SEWAGE DISPOSAL SYSTEM

HOWARD COUNTY
BUREAU OF ENVIRONMENTAL HEALTH
461-9933

SUBDIVISION Forest Hills ROAD 5834 Trotter Road LOT 11

PROPERTY OWNER Fritz Rathjens
5834 Trotter Road

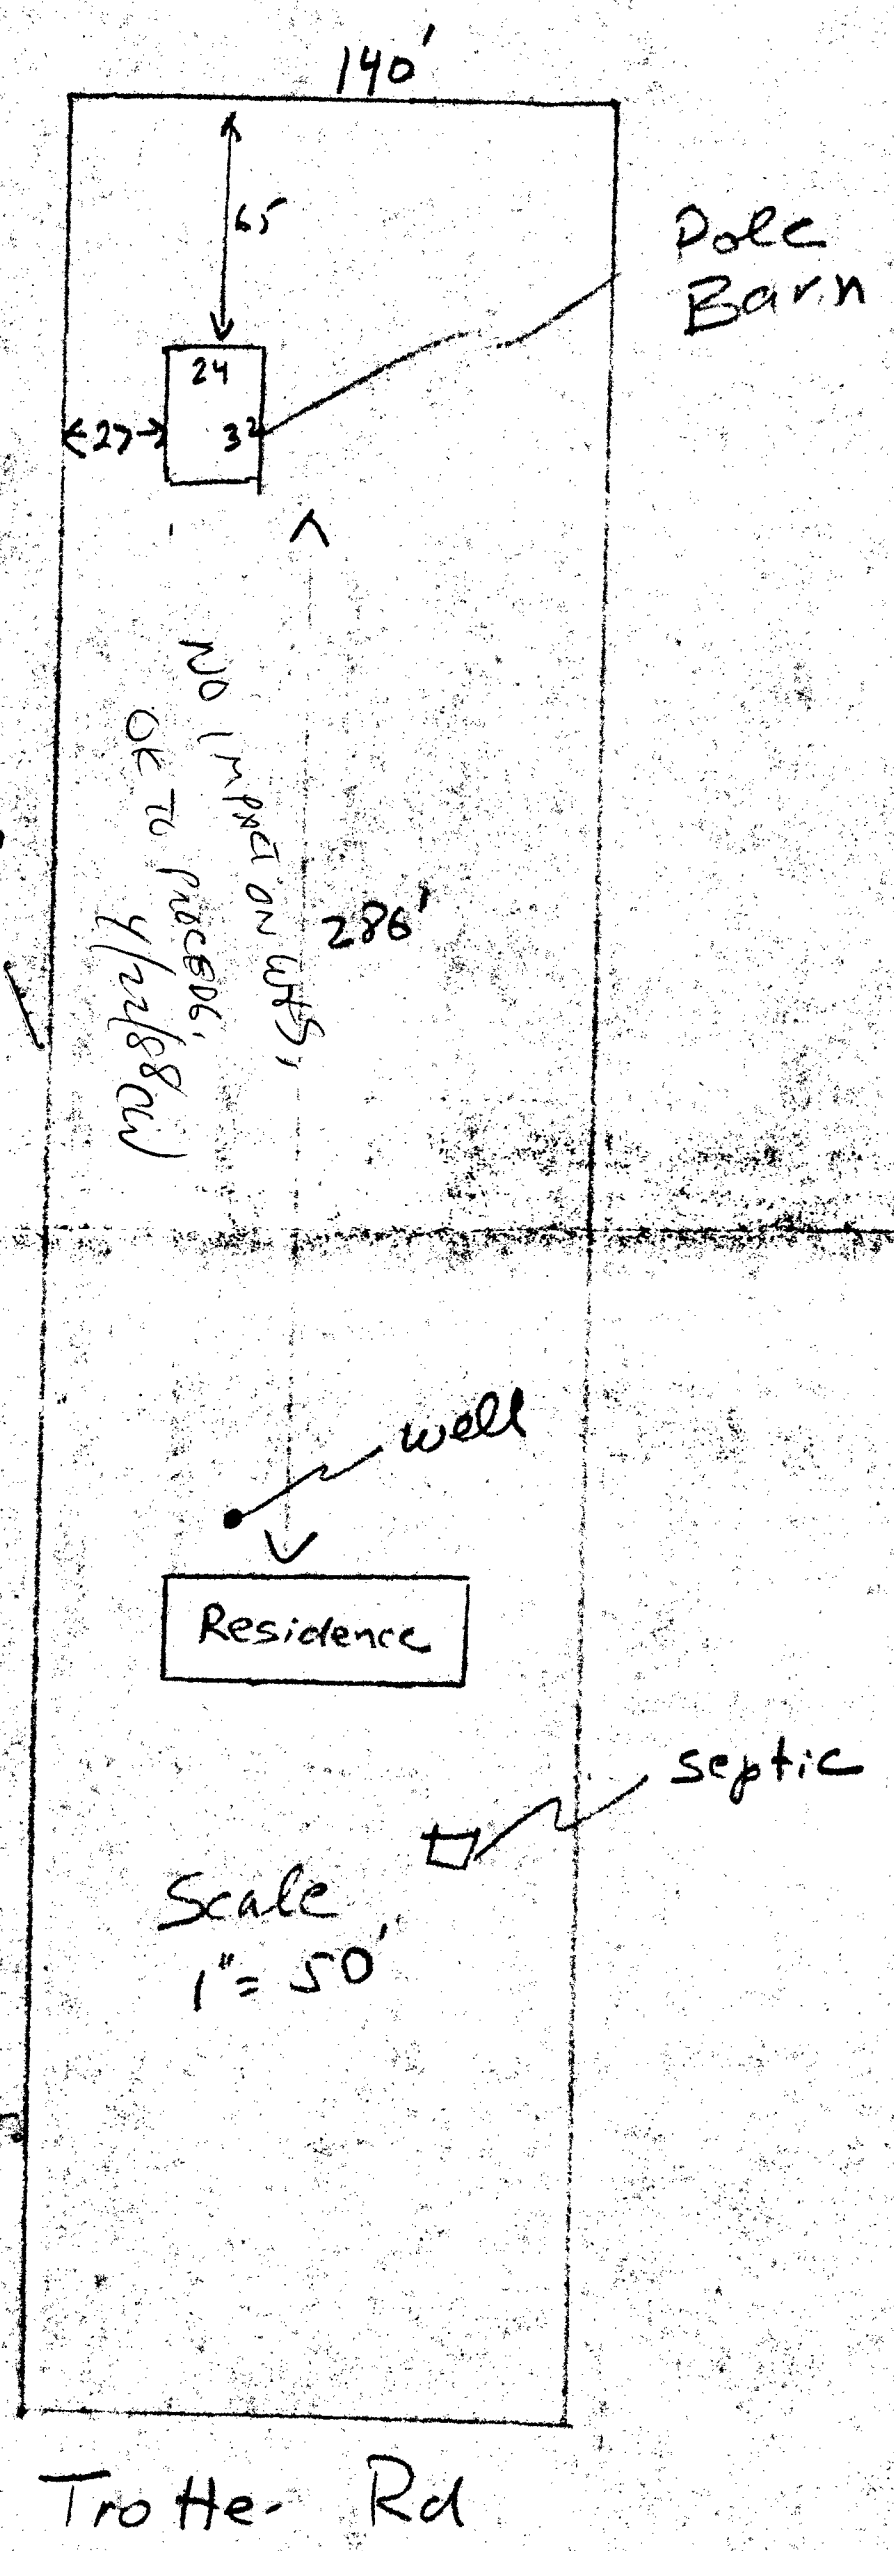
REMARKS 4/21/88 EXISTING TANK 5' IN GROUND. EXISTING DRYWELL 12' D66P, DEFINITELY IN GROUND.

① TEST HOLE 1 - WATER AT 6' MOTTLED AT 3 1/2' - NO OPPORTUNITY FOR GRAVITY REPAIR.

② TEST HOLE 2 - SILT LOAN 3-13'

RECOMMEND - INSTALL - 80' TRENCH, 6' STONE AT PERC HOLE ②. 2-40' TRENCHES REQ'D TO AVOID SWALS. C. Williams

4/21/88 - TRENCHES OK INSTALL PUMP & CALL R/H
